**Moorebank Precinct West (MPW) Stage 2 (SSD 7709) Response to Submissions**

**SSD16-7709**

## **ATTACHMENT A – RESPONSE TO ISSUES RAISED IN NSW DP&E SUBMISSION**

Figure 1 Single area source regions used in the construction noise impact assessment

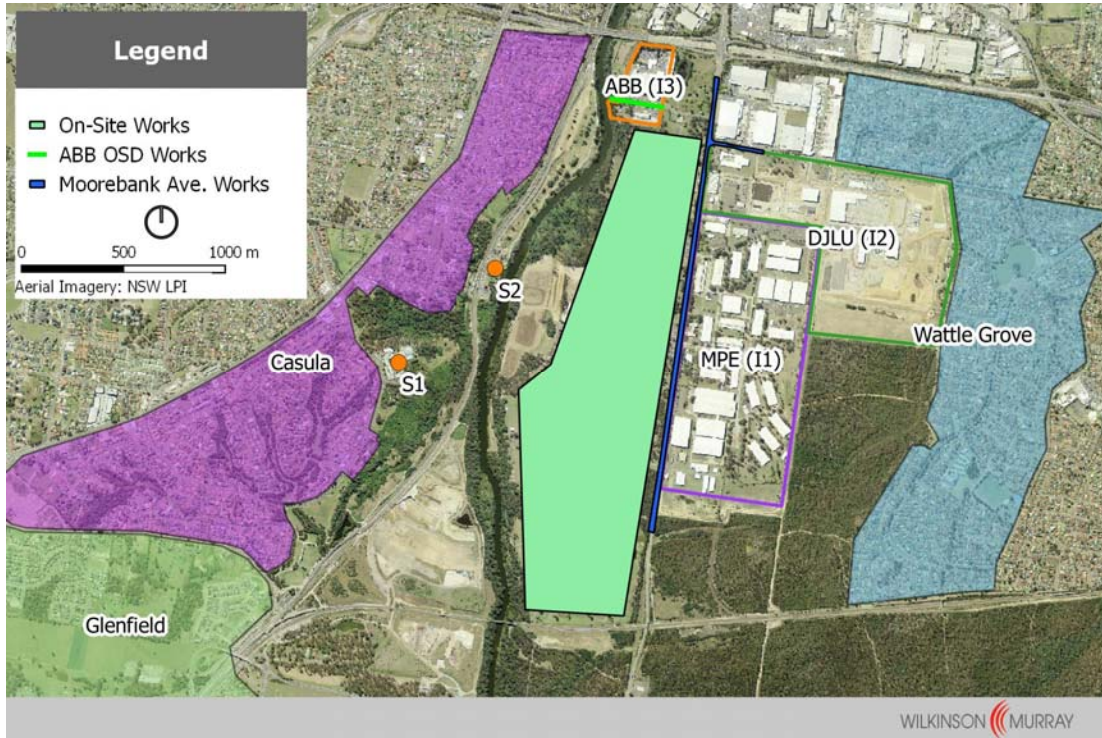
Construction site plan	Provide separate site plan showing each of the seven construction stages' equipment placements used in the model, relative to surrounding land-uses;	As discussed in Section 8.4 of the EIS, a total sound power level (SWL) was developed for each works period that was representative of all plant in the period operating simultaneously. Each SWL was then modelled as a single area source based on the footprint of the work period. These source regions are provided in Appendix D of the MPW Stage 2 RtS.  For the works period involving Moorebank Avenue, the total SWL of all plant as a single area source was modelled over the region shown on the figure. Since that works period also involved the internal roads on the MPW site, activities on the MPW site were also modelled, and then the highest predicted noise levels for each catchment was presented.  For the additional covered drain within the Endeavour Energy easement, as identified for the Amended Proposal, plant items were modelled as a line source, as shown in the figure provided at Appendix D of the MPW Stage 2 RtS.	Section 8.4 of the EIS.  Appendix D of the MPW Stage 2 RtS

**Figure 1 Noise Monitoring Locations**

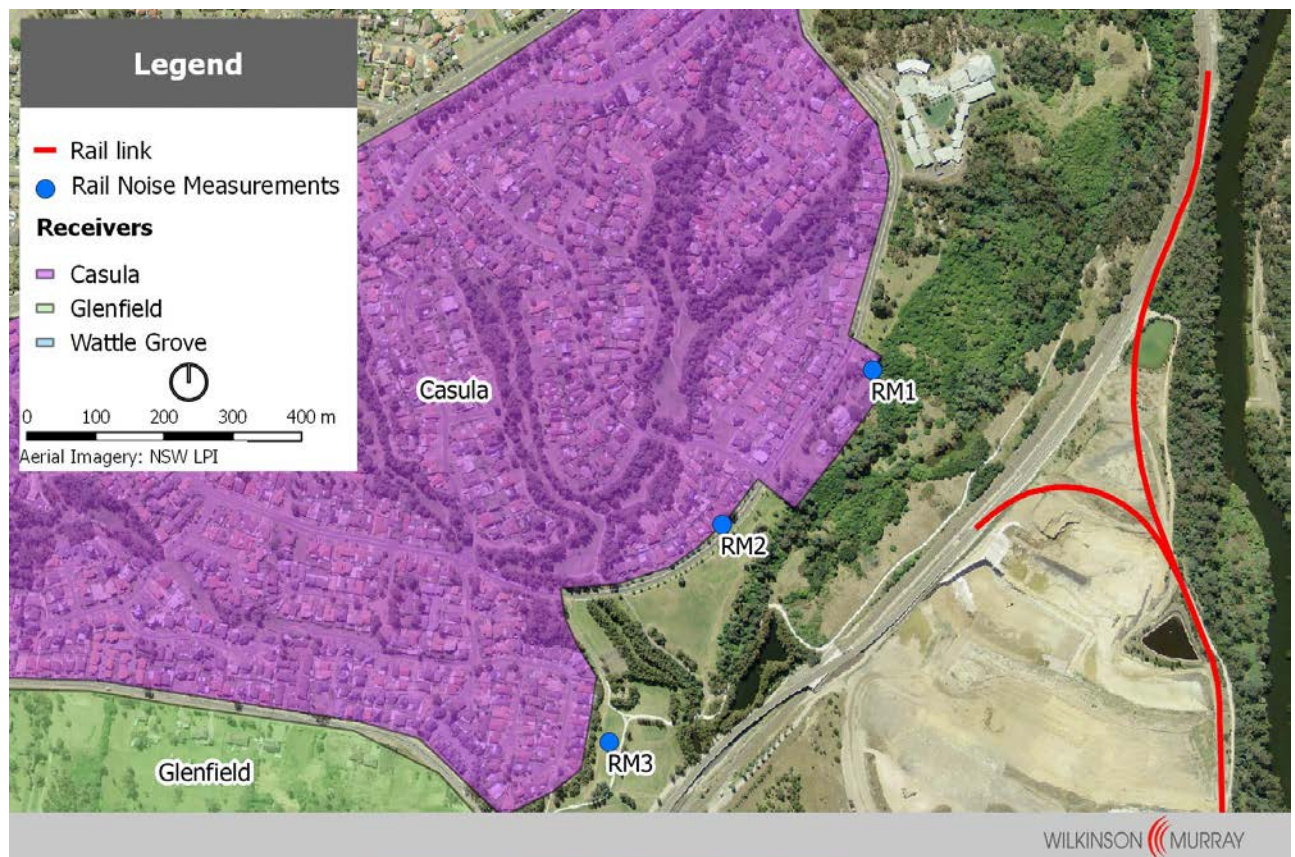
Aspect	Comment	Response	Reference
<b>Noise Issues</b>			
Ambient noise monitoring	Provide ambient noise monitoring data charts and/or raw electronic data from locations L1 to L3 as referenced from the MPW Concept Plan EIS (precise reference not provided and seemingly no longer available online);	Ambient noise monitoring data, in the form of noise logger plots were included in Appendix B of <i>Technical Paper 2: Noise and Vibration Impact Assessment</i> (SLR Consulting, 2014); prepared to support the Moorebank Intermodal Terminal Concept EIS. <a href="https://majorprojects.affinitylive.com/public/246a966ba837c880137b190133ac9dd7/050%20Technical%20Paper%20_%20Noise%20and%20vibration%20(Part%20B).pdf">https://majorprojects.affinitylive.com/public/246a966ba837c880137b190133ac9dd7/050%20Technical%20Paper%20_%20Noise%20and%20vibration%20(Part%20B).pdf</a> .	Appendix B of the MPW Concept Approval EIS.

**Figure A-2 Night Time  $L_{Aeq, 15min}$  Operational Noise Levels – Calm Meteorological Conditions**

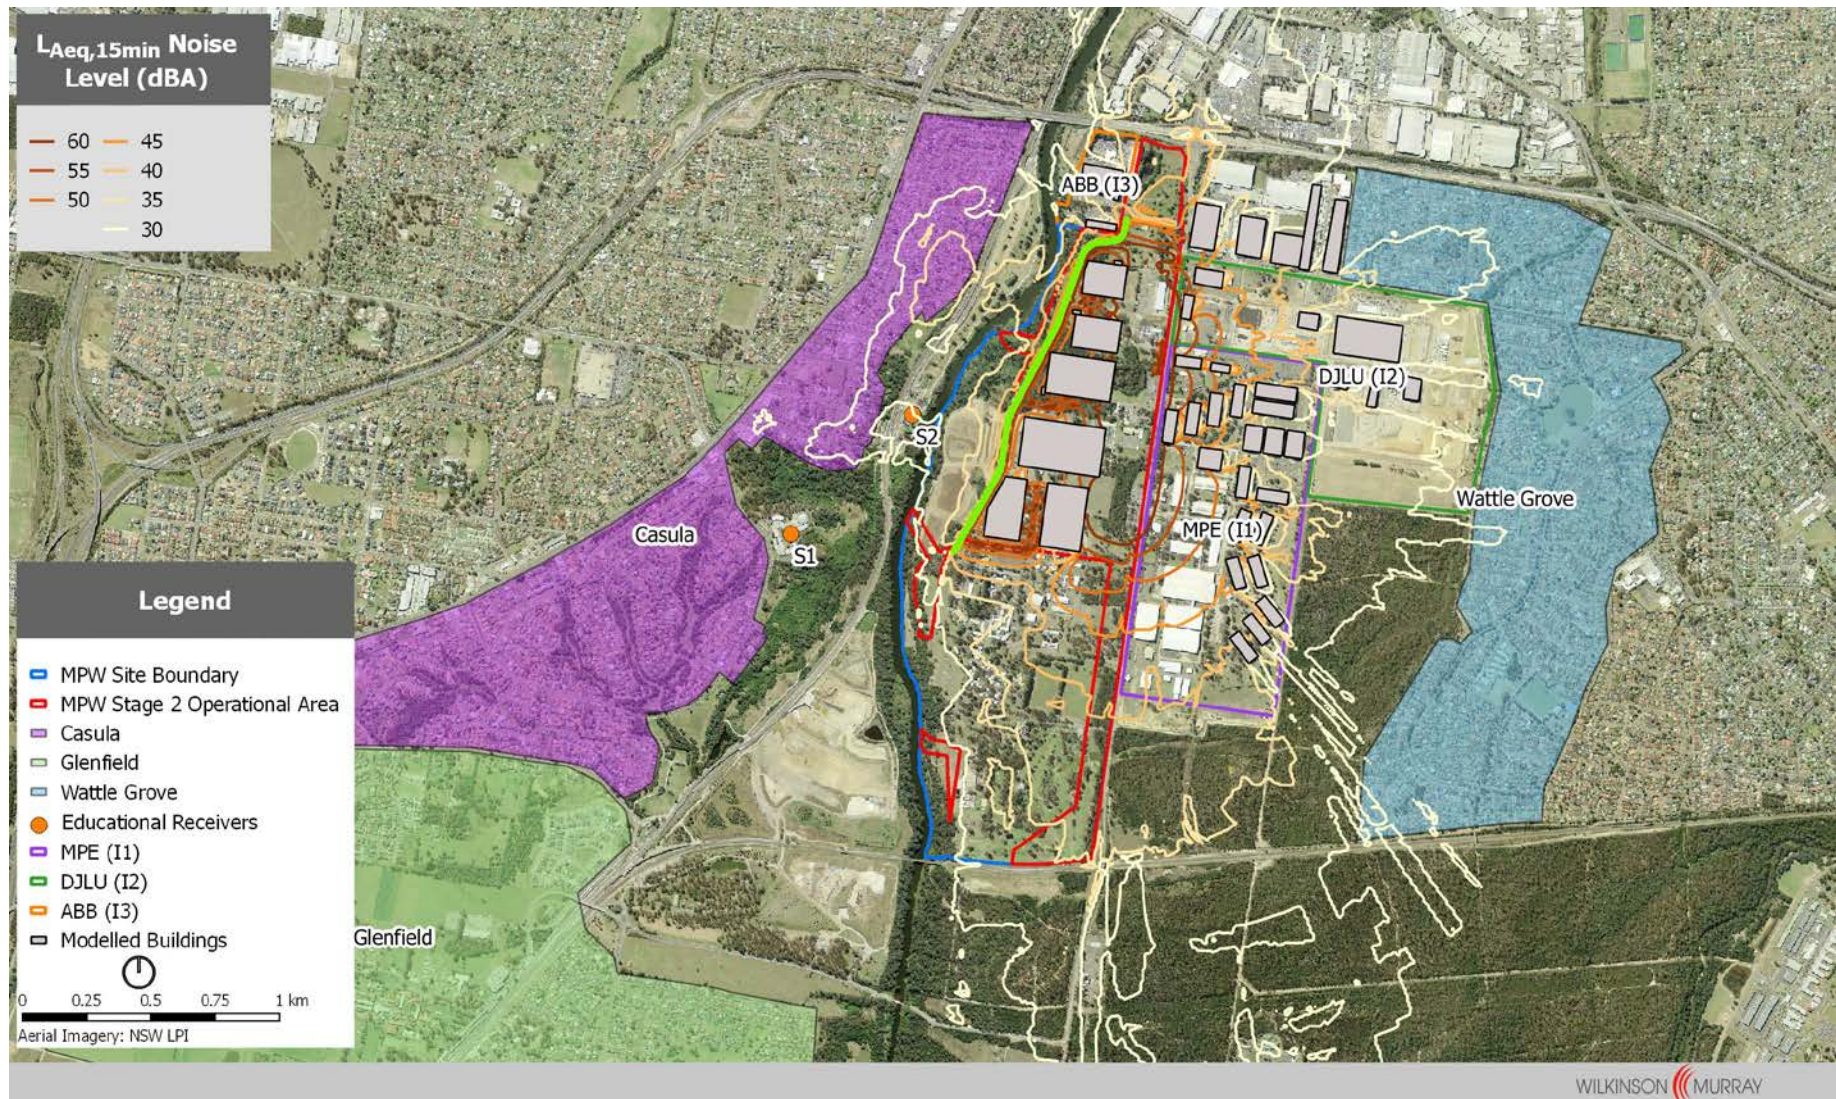
Meteorological conditions	Clarify meteorological conditions used in modelling for the night time period (see section 7.1.2 of the noise impact assessment (NIA));	<p>Night time operational noise levels were predicted for two meteorological scenarios; calm and adverse.</p> <p>‘Calm’ meteorological conditions used for night-time operational noise modelling were based on Pasquill-Gifford stability class D (CONCAWE Weather Category 4) which is characterised by no wind and a mild temperature lapse.</p> <p>‘Adverse’ meteorological conditions used for night-time operational noise modelling were based on Pasquill-Gifford stability class F (CONCAWE Weather Category 6), which is characterised by source to receiver winds up to 3m/s and/or temperature inversion.</p> <p>These conditions are considered consistent with Section 5 of the <i>Industrial Noise Policy</i> (INP) (NSW EPA, 2000) to assess operational activities.</p>	Section 5 of the NSW EPA <i>Industrial Noise Policy</i>
